EDWIN I. HATCH NUCLEAR PLANT, UNIT NO. 1

AMENDMENT TO FACILITY OPERATING LICENSE

Amendment No. 121 License No. DPR-57

ATTACHMENT TO LICENSE AMENDMENT NO. 121

FIGURE 2.1-1 REACTOR VESSEL WATER LEVEL

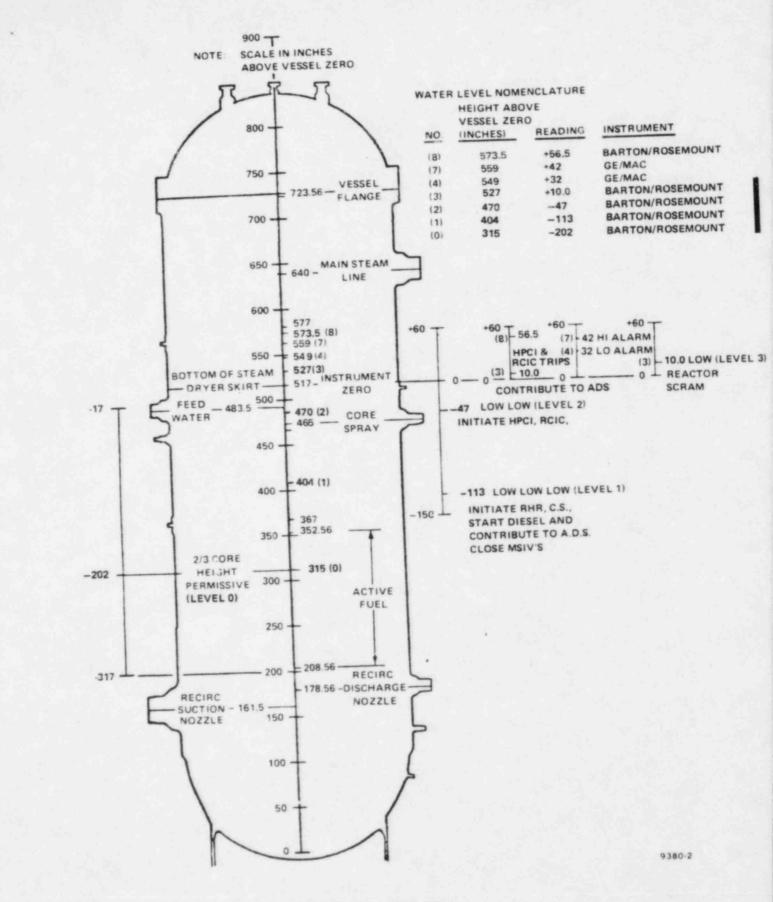
Replace the following pages of the Appendix "A" Technical Specifications with the attached pages. The revised pages are identified by Amendment number and contain vertical lines indicating the area of change.
